CALVERT CLIFFS NUCLEAR POWER PLANT, UNIT NO. 1

AMENDMENT TO FACILITY OPERATING LICENSE

Amendment No. 39
License No. DPR-53

ATTACHMENT TO LICENSE AMENDMENT NO. 39

FIGURE 2.2.2
Thermal Margin/Low Pressure Trip Setpoint
Part 1 (ASI Versus A_1)

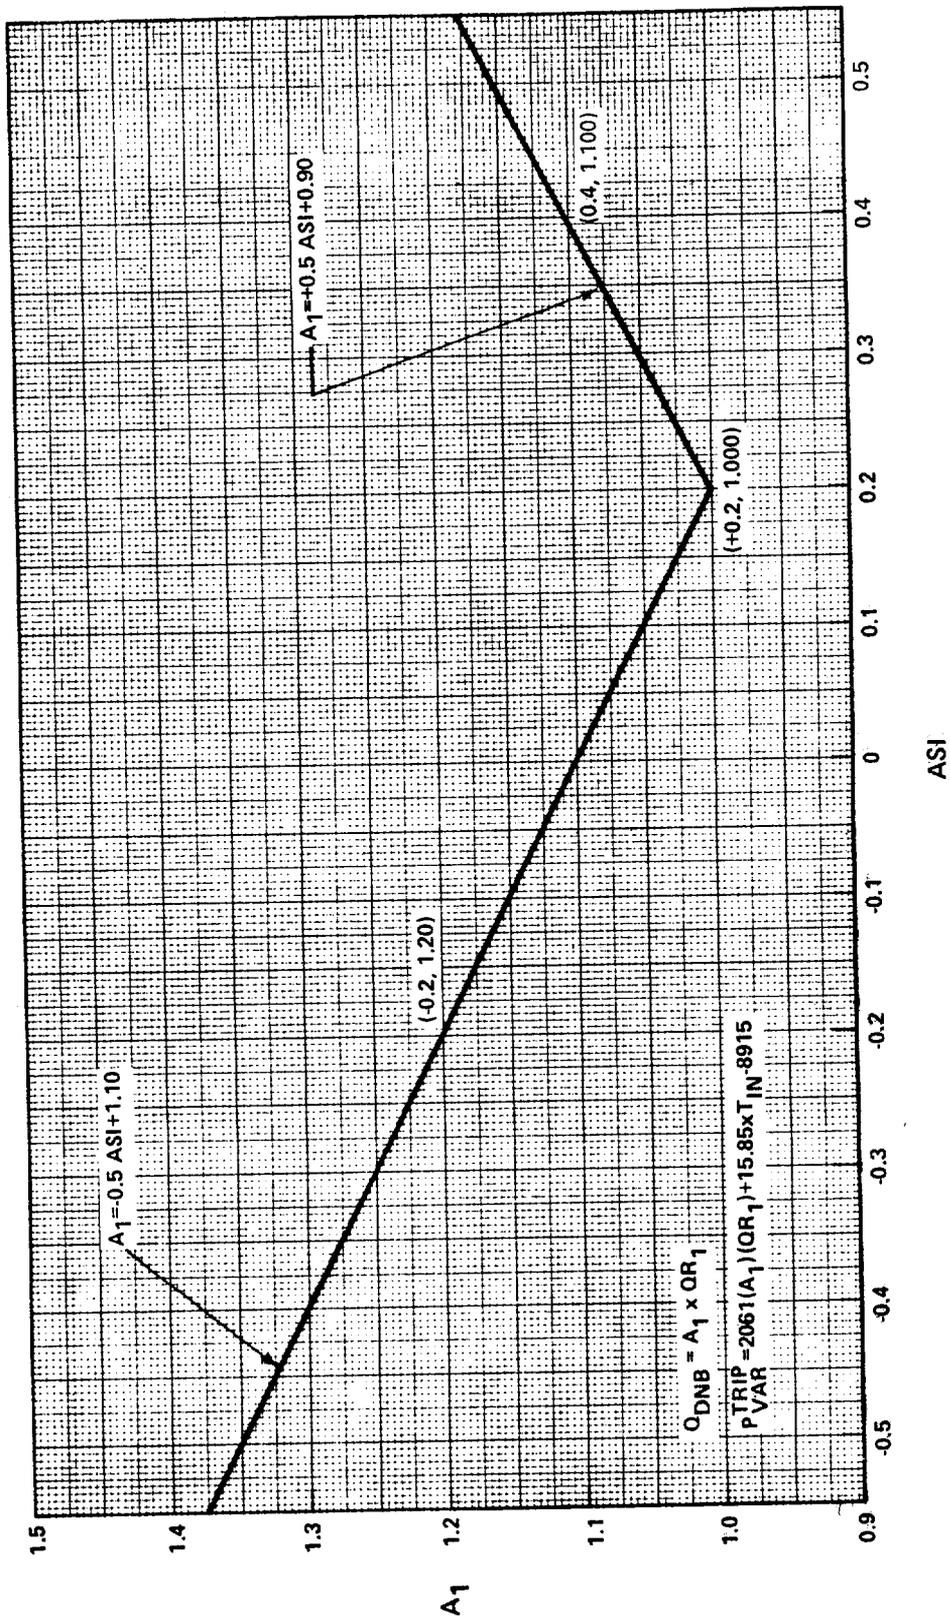
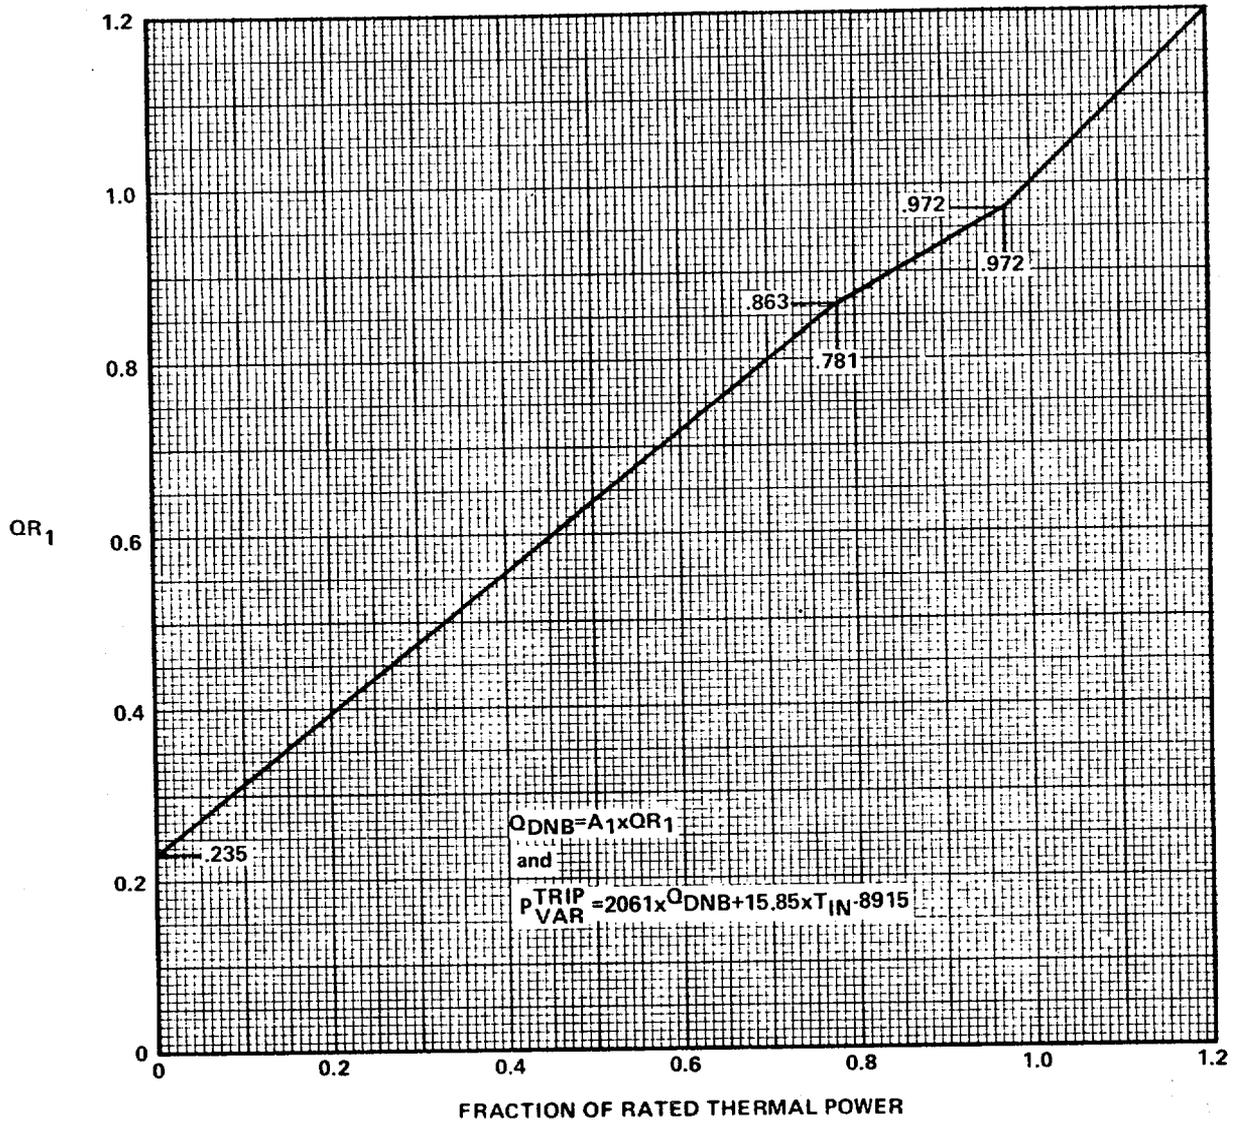
Figures 2.2-2 and 2.2-3, relating to the TM/LP trip setpoint, would be modified as a result of the Cycle 4 analyses.

FIGURE 3.2-2
 Linear Heat Rate
 Axial Flux Offset Control Limits

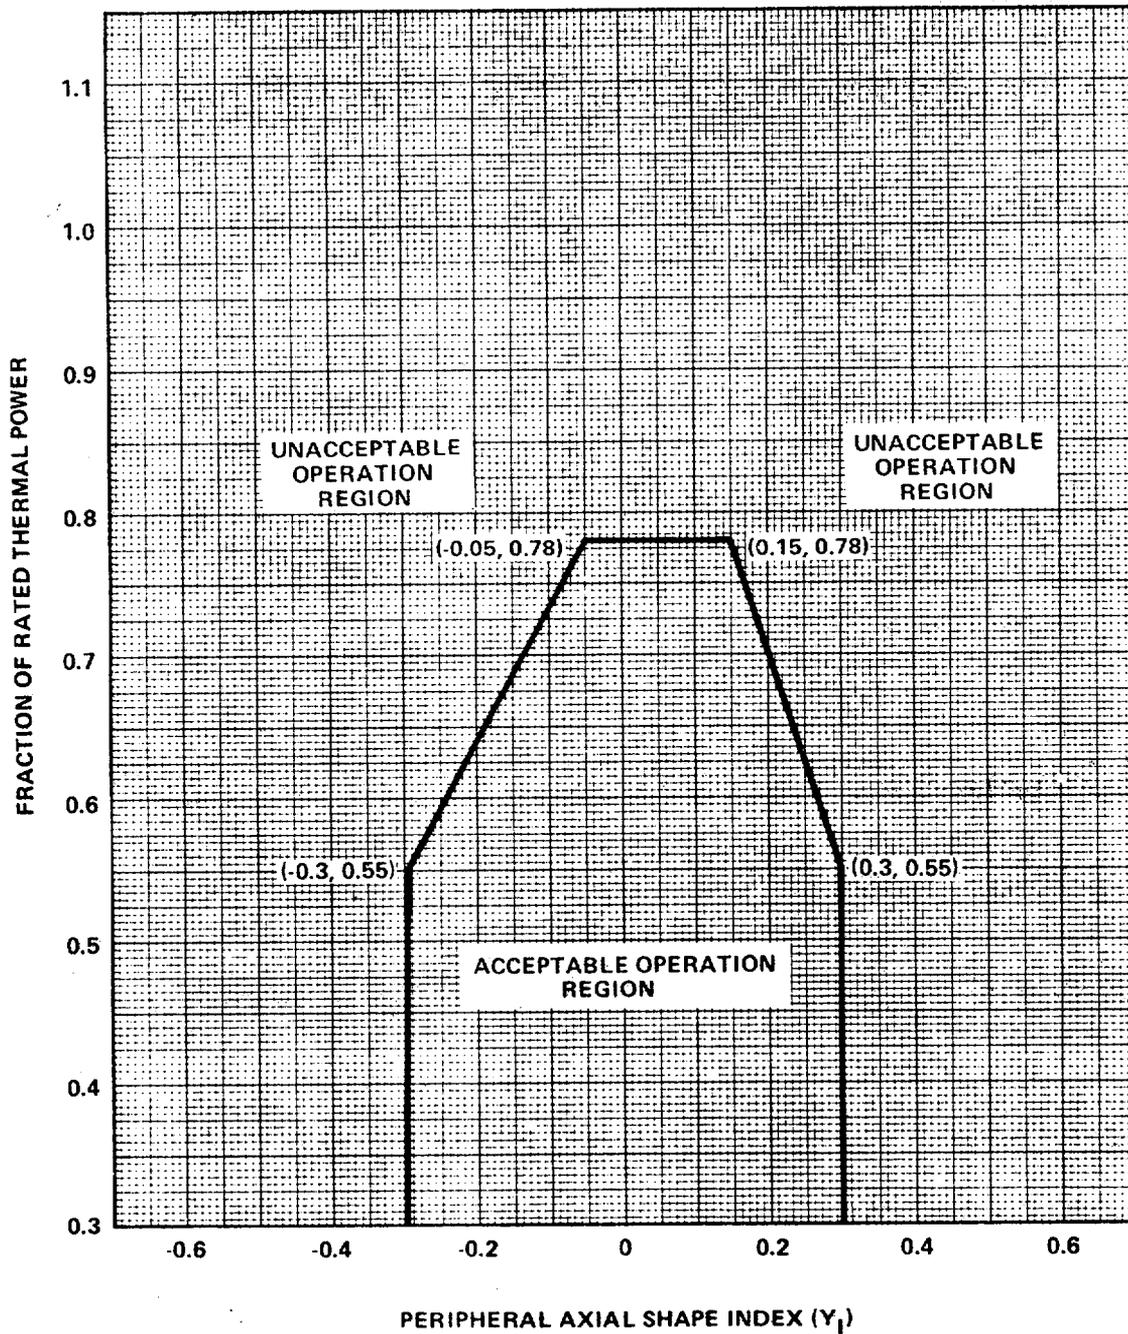
New axial flux offset (Figure 3.2-2) and augmentation factors (Figure 4.2-1) would be added based on revised physics calculations.

FIGURE 3.2-4
DNB Axial Flux Offset Control Limits

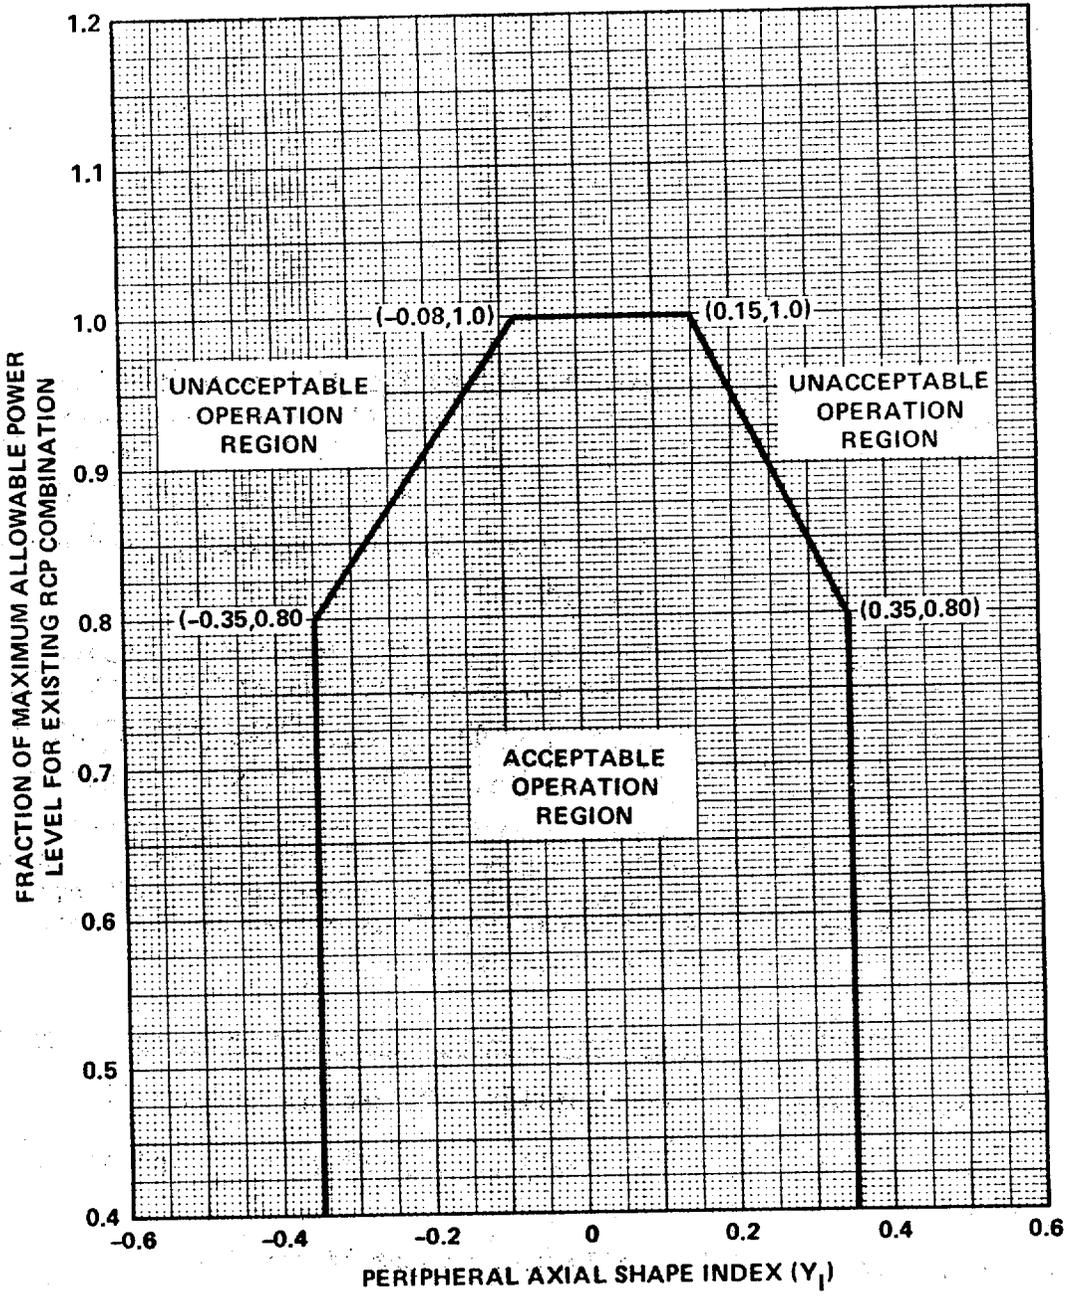
Figure 3.2-4 would include the increase in allowable azimuthal tilt.
